Millstone Nuclear Power Station, Unit No. 3  
Relief Requests for the Second Ten Year Interval  
of Inservice Inspection Program

Response to Request for Additional Information

Revised Relief Requests IR-2-25 and IR-2-26

FIG. IWB-2500-13 INTEGRAL ATTACHMENT WELD

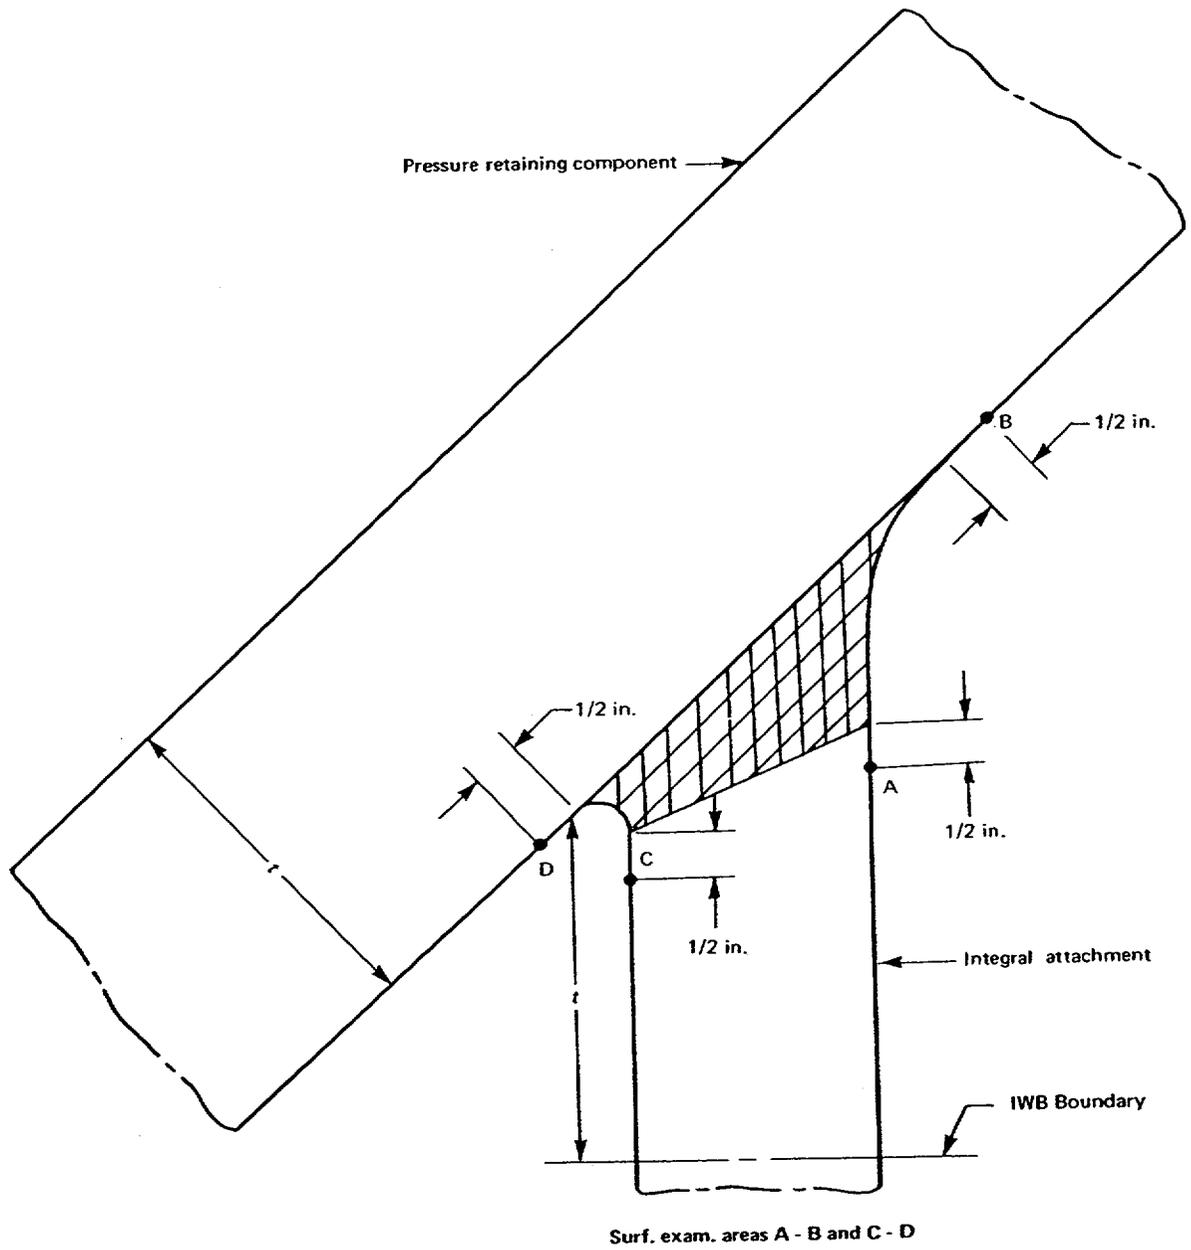
The licensee's proposed relief request is similar to Code Case N-323-1. This code case is listed in Draft Regulatory Guide DG-1112, "ASME Code Cases Not Approved For Use." The staff has accepted surface and UT examinations from the accessible surface. (See safety evaluation for Brown's Ferry Nuclear Station, Units 2 and 3, 2<sup>nd</sup> 10-year ISI interval dated June 19, 200, and Browns Ferry, 3<sup>rd</sup> 10-year interval, relief request 2-ISI-10, Revision 1, dated February 4, 2002)

Pursuant to 10CFR50.55a(g)(5)(iii) relief is requested from performing the surface examination on the inaccessible portions of the pressurizer support skirt to vessel shell weld. The inaccessible portion corresponds to the interior surface C-D as shown in Figure IWB-2500-13.

Geometric configuration of the support skirt-to-shell weld limits the surface to be examined to the one accessible side, corresponding to examination surface A-B, as shown in Figure IWB-2500-13. The attached sketch shows the interior portion of the subject weld to be inaccessible to a meaningful surface examination. Also, high radiation levels within the support skirt would result in an estimated personnel exposure of an additional 7.2 Rem to complete the scaffolding, insulation removal/replacement, weld preparation and best effort examination.

Relief Request IR-2-26 has been revised to add an ultrasonic examination. See revised relief request IR-2-26 in Attachment 2 which supercedes the original and addresses this question. Revision bars are included in the left margin to indicate the changes from the original submitted on September 27, 2001.

- A The subject weld will receive a surface examination of the accessible exterior weld surface A-B as shown in Figure IWB-2500-13, in accordance with ASME Section XI (IWB-2500-1).
- B. The subject weld will receive a best effort UT examination to achieve the maximum practicable coverage of the required examination volume as depicted in figure IWB-2500-13. This examination will be performed from the outside surface of the skirt attachment.

Based on the surface examination performed on 100% of the exterior weld surface A-B as shown in Figure IWB-2500-13 and a best effort UT examination from the outside surface of the skirt attachment, DNC believes the proposed alternative will provide an acceptable level of quality and safety by providing reasonable assurance of structural integrity of the subject weld.
